APPLICATION NO.	FILING DATE	FIRST NAMED INVENTOR	ATTORNEY DOCKET NO.	CONFIRMATION NO.
09/934,482	08/23/2001	Naoya Motegi	ASA-1025	8422

Office Action Summary

FIG. 4

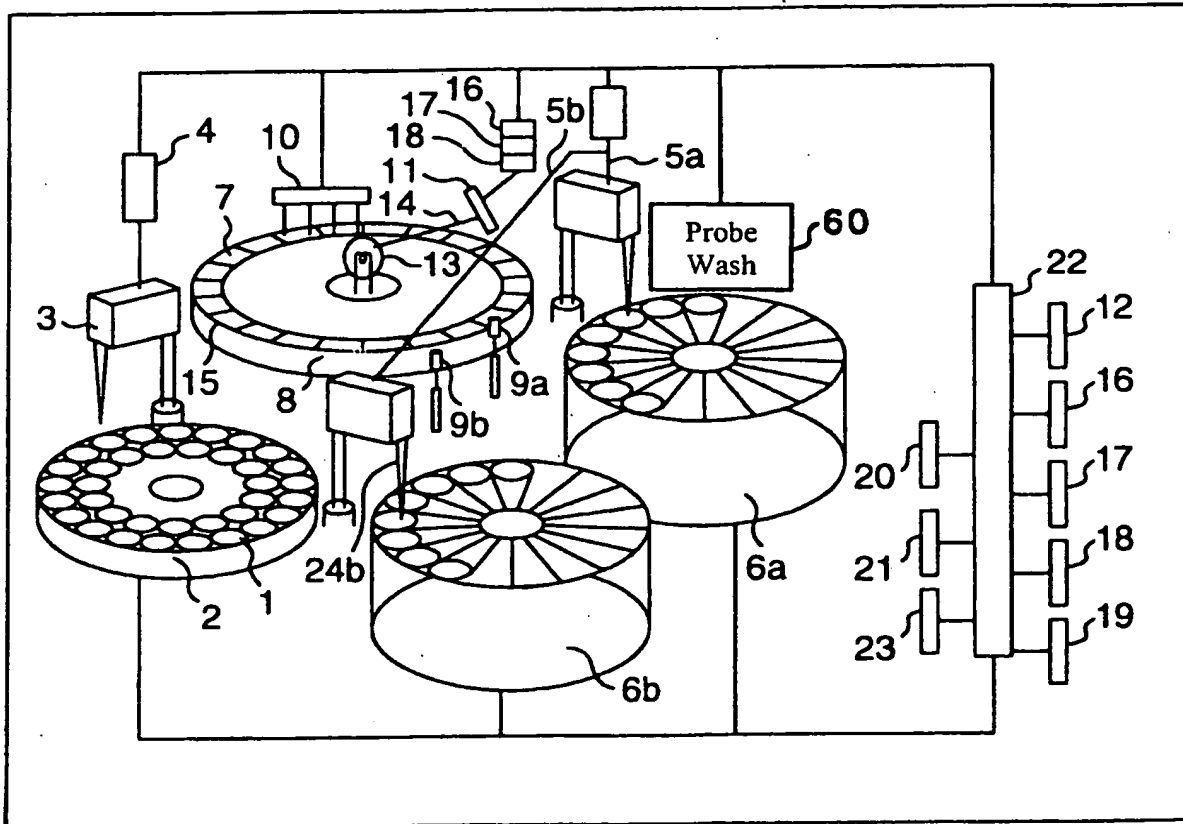
2. The drawings were received on June 30, 2005. These drawings are accepted.
3. The drawings are objected to as failing to comply with 37 CFR 1.84(p)(5) because they include the following reference character(s) not mentioned in the description: 60 in the newly submitted replacement drawing. Corrected drawing sheets in compliance with 37 CFR 1.121(d), or amendment to the specification to add the reference character(s) in the description in compliance with 37 CFR 1.121(b) are required in reply to the Office action to avoid abandonment of the application. Any amended replacement drawing sheet should include all of the figures appearing on the immediate prior version of the sheet, even if only one figure is being amended. Each drawing sheet submitted after the filing date of an application must be labeled in the top margin as either "Replacement Sheet" or "New Sheet" pursuant to 37 CFR 1.121(d). If the changes are not accepted by the examiner, the applicant will be notified and informed of any required corrective action in the next Office action. The objection to the drawings will not be held in abeyance.
